**Fwd: Eureka HAWS CIRNAC comment on effluent lines/decanting hose**

RE: CIRNAC Land Use inspection at Eureka (Summer 2023) and comment about effluent lines/decanting hoses:

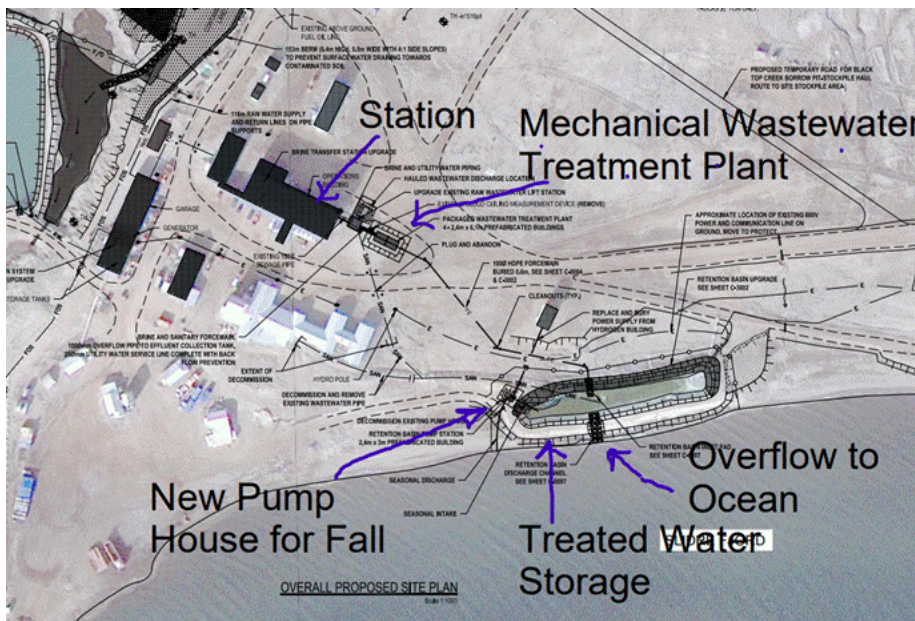
- *Ensure the end of the effluent lines/decanting hoses are over 31 metres from the high-water mark of any water body before pumping. Ensure all effluent parameter quality limits are not in exceedance.*

- 1) the issuance of the NWB Water Licence (Type B Amendment Approval issued on June 13, 2022 ) approved the Wastewater Treatment Plant and design shown below and
- 2) there are no modifications to this in the new Type A licence Approval (issued December 19, 2023) in this regard.

At present the existing lagoon treats the wastewater and it is disposed of in the ocean by pumping. The discharge and pumping occurs after the lagoon has been tested and it meets license limits. The discharge is direct to the ocean, so there is very limited erosion associated with the existing pumping process. Movement of the pump discharge to 100 ft away from the ocean could be done, with enough hose and with construction of a discharge swale. However due to the conditions onsite it is believed that development of a discharge path 100 ft from the ocean could result in additional erosion, and it is not recommended. The existing lagoon treatment process is set for replacement with a mechanical treatment system and should be fully operational by 2025.

By 2025, all wastewater will be collected and treated in a moving bed bioreactor (MBBR) mechanical treatment plant adjacent to the weather station. This treatment facility will meet current Wastewater Systems Effluent Regulation (WSER) federal guidelines at well over a 100 ft from the water way. This will be high quality effluent that will be stored in the old lagoon prior to discharge. The treated water will be stored during winter rather than being released on or beneath the ocean ice. The storage cell will be the old lagoon after it is cleaned out and expanded, at which time it will be a retention pond. **During the summer, the retention pond will overflow to the ocean through a channel lined with rip rap (see second drawing below). In the fall, the treated water will be pumped out of the retention pond to make space for the winter storage. Both the pumping and the overflow will be adjacent to the ocean, however they will be releasing stored treated wastewater. This outfall will not meet a 100 foot distance offset from the ocean but it will be discharging treated water meeting the WSER limits.**
